Service Bulletin SB 2X-34-08 R1

Revised: 06 May 2005

ATA 34-10: Flight Environmental Data/Pitot-Static Systems OAT Probe Ground Wire Installation

Figure 01 - OAT Probe Ground Wire Installation

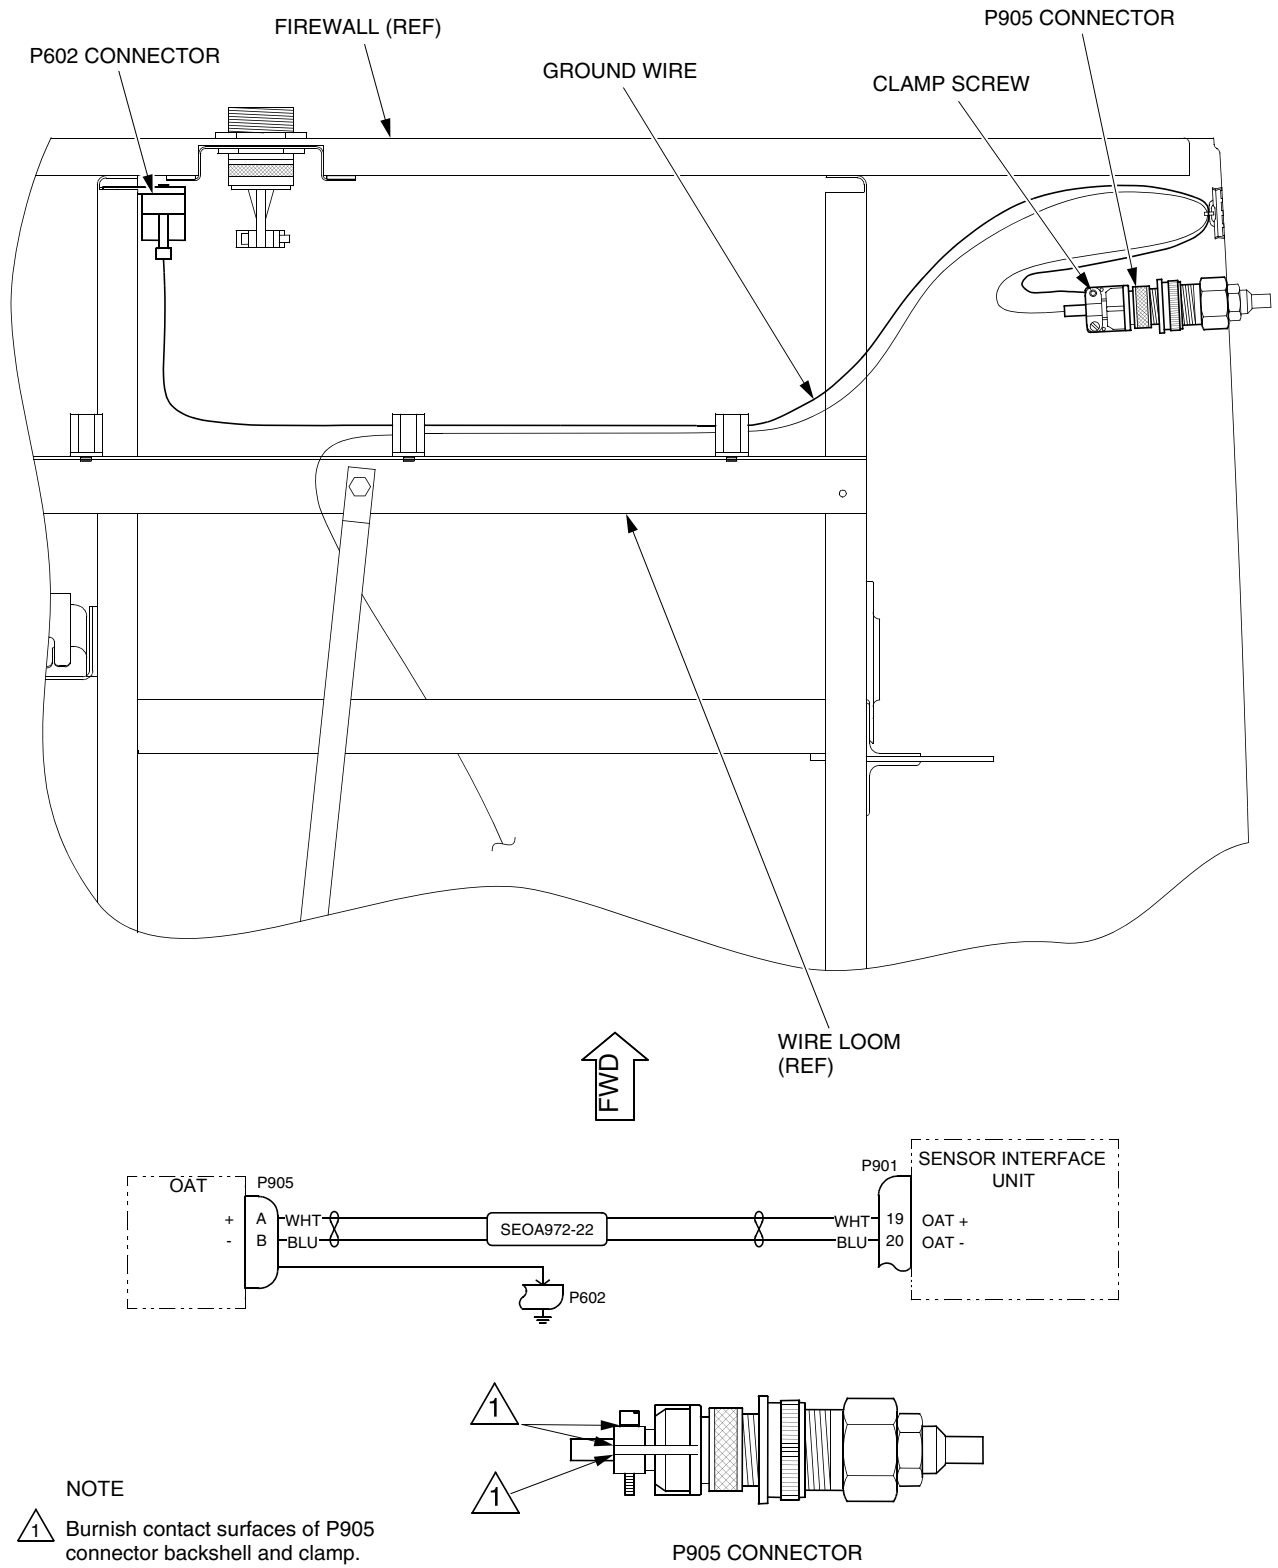
- F. Remove RH kick plate. (Refer to AMM 25-10)
- G. Install ground wire. (See Figure 01)
 - 1. Locate OAT probe installed immediately forward of the passenger's door. (Refer to AMM 34-10)

- 2. Remove clamp screw from P905 connector backshell of OAT probe.
 - 3. Attach terminal ring from ground wire to P905 connector backshell with clamp screw.

- 4. Bundle ground wire to existing harnesses using adel clamps and cable ties where necessary.
 - 5. Disconnect P602 from firewall ground jack.
 - 6. Using insertion tool, connect pinned end of ground wire to P602 plug into any available pin receptacle.

- 7. Reconnect P602 to firewall ground jack.
- H. Using Ohmmeter, verify resistance from OAT probe to aircraft ground is less than 2 Ohms.
 - 1. Position one Ohmmeter lead to tip of OAT probe and other lead to a suitable airplane ground such as the tailpipe.

- a. Remove clamp screws securing ground wire and clamp to P905 connector backshell.
 - b. Using 80-grit sandpaper, burnish contact surfaces of P905 connector backshell and clamp. (See Figure 01)
